Project **Brownsbarn Site N7 Landscape Design**

Title **Landscape Masterplan**  
for  
Client **Exeter Ireland Property Limited**

Drawn: CZ	03/02/2022	Designed: CZ	12/01/2022
Checked: CP	03/02/2022	Approved: BOC	03/02/2022
Project Reference: 2020s1431		Scale: As Shown @ A1	
Drawing Number: ENO-JBAI-XX-XX-DR-L-0002	Status: A3	Revision: C06	Sheet Size: A1

Typical Tree pit detail Scale 1:50 @ A1  
All measurements in mm

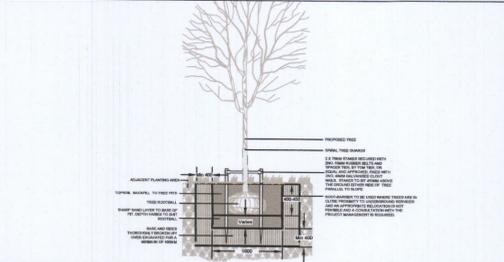
3. A tree pit detail has been added into the carpark design which adjacent to hard standing surfaces, this will allow incorporated SuDS.
4. Tree planting along the N7 has been kept close to the proposed buildings to allow for maximum retention of views from the N7 towards the *Specialized Ireland* while enhancing screening of the proposed building and provision of habitat.
